Appl. No. 09/639,163  
Confirmation No. 3891

For: METHOD OF PRODUCING  
SEMICONDUCTOR DEVICES USING A  
HYDROGEN PEROXIDE-WATER  
MIXTURE (AS AMENDED)

**PETITION TO WITHDRAW HOLDING OF ABANDONMENT**

*FIG. 3(A)*

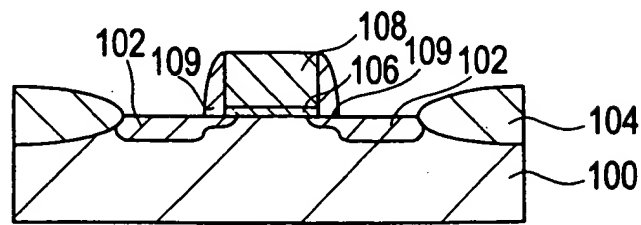
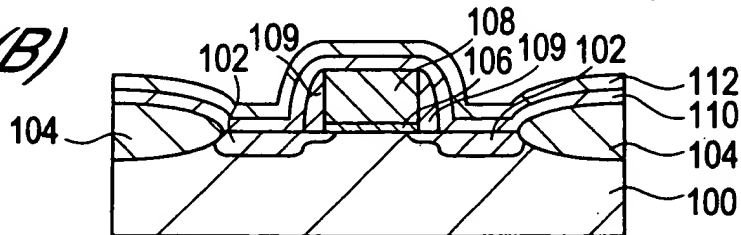
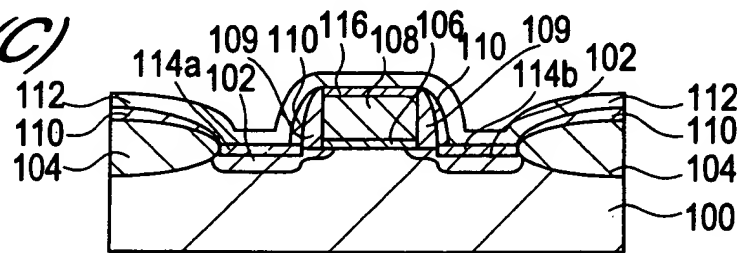
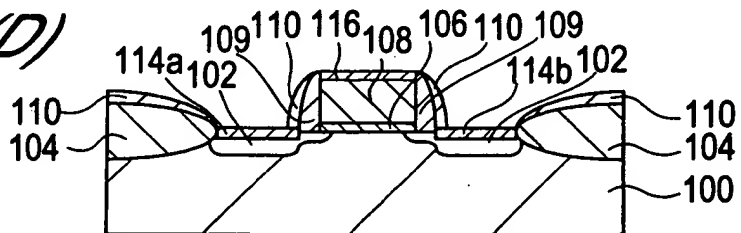
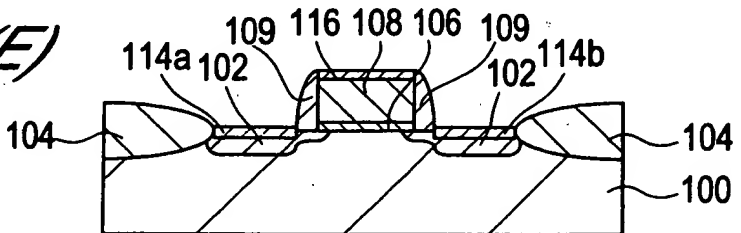
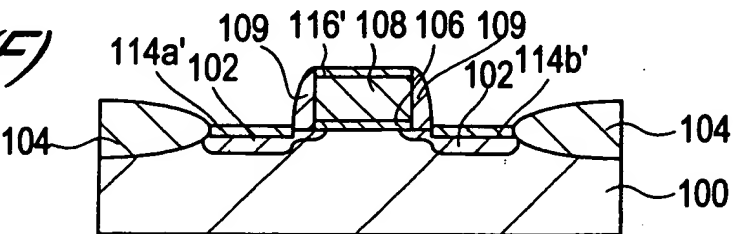
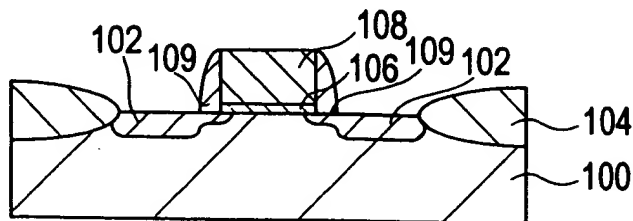
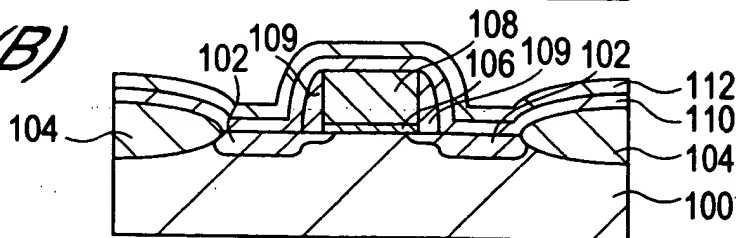
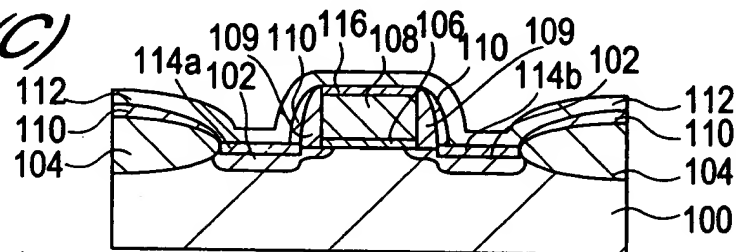
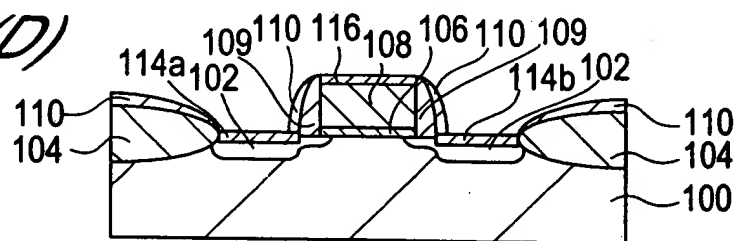
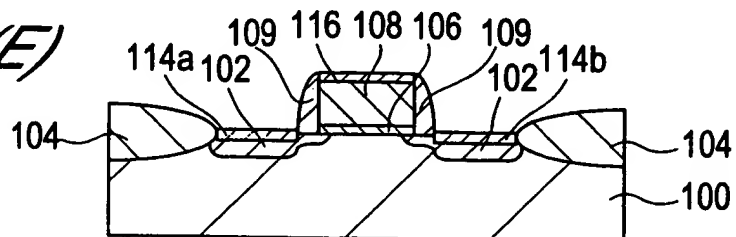
In an Office Action mailed October 24, 2001, the Examiner objected to the drawings filed in the above-identified application. In making the objection, the Examiner indicated that Figures 3(A)-3(F) and Figure 4 should be designated by a legend such as --Prior Art-- because only that which is old was illustrated. On January 24, 2002, two sheets of formal drawings were filed with an accompanying amendment in response to the Office Action mailed October 24, 2001. In that submission, the sheet containing Figures 3(A)-3(F) contained one label for all figures and the sheet containing Figure 4 contained one label for Figure 4. A true and correct copy of the Figure 4 that was submitted on January 24, 2002, as well as the stamped filing receipt indicating that the drawings were received is enclosed herewith as Exhibit A.

Thereafter, Applicant received a second Office Action mailed on April 24, 2002. In the second Office Action (Paper No. 8), the Examiner indicated that the drawing proposals submitted on January 24, 2002 were not acceptable because the "Prior Art" label should be listed under each figure, and Figures 3(A)-3(F) were not individually labeled as "Prior Art." A true and correct copy of Paper No. 8 is attached as Exhibit B. Figure 4 was properly labeled because Figure 4 was individually labeled as "Prior Art," as indicated by Exhibit A.

1. Applicant's newly submitted drawing proposals are not acceptable. The term "Prior Art" label should be listed under each figure.

On July 31, 2003, a Notice of Allowance and Notice of Allowability were mailed. The Notice of Allowability indicated that corrected drawings including the changes required by Paper No. 9 must be submitted. On February 17, 2004, Applicant's Representative conducted a telephonic interview with the Examiner, who indicated that the Notice of Allowability should have read Paper No. 8, not Paper No. 9 and that the number 9 was inadvertently typed. Therefore, the Notice of Allowability required that each Figure 3(A)-3(F) be individually labeled as "Prior Art", as required by Paper No. 8.

On September 12, 2003, Applicant filed a Submission of Formal Drawings, which included properly labeled formal drawings for Figures 3(A)-3(F), in response to the Notice of Allowance. A true and correct copy of the Submission of Formal Drawings, as well as the stamped filing receipt indicating that the drawings were received is enclosed herewith as Exhibit C. Shortly thereafter, the issue fee was paid.

*FIG. 4*

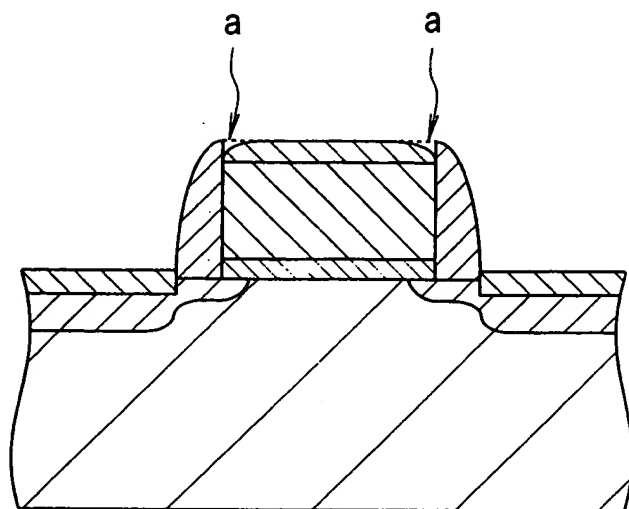
On December 15, 2003, a Notice of Abandonment was mailed indicating that the above-identified application was abandoned because Applicant failed to timely file corrected drawings. After repeated attempts to learn of the reason for abandonment, Applicant finally received a message from the abandonment contact person (Mr. Tom Hawkins), on January 30, 2004, and learned that the above-identified application was abandoned because a properly labeled Figure 4 was not received. Applicants respectfully disagree.

Based on the foregoing, Applicants respectfully submit that the Notice of Abandonment was issued due to PTO error. Exhibit A proves that a properly labeled Figure 4 was received by the Patent Office on January 24, 2002. Exhibit C proves that properly labeled Figure 3(A)-3(F) were received by the Patent Office on September 12, 2003. Accordingly, Applicant has fully responded to the Examiner's objection to the drawings in the Office Action mailed October 24, 2001, and complied with the Examiner's request that Figures 3(A)-3(F) and Figure 4 be labeled as "Prior Art". Therefore, Applicant respectfully submits that this case is not in fact abandoned and should be passed to issue. Further, no petition fee should be due. Applicants submit that this petition is filed within the requisite two month period because it is being filed on the next succeeding business day following a Federal Holiday, as is permitted by 37 C.F.R. §1.7(a).
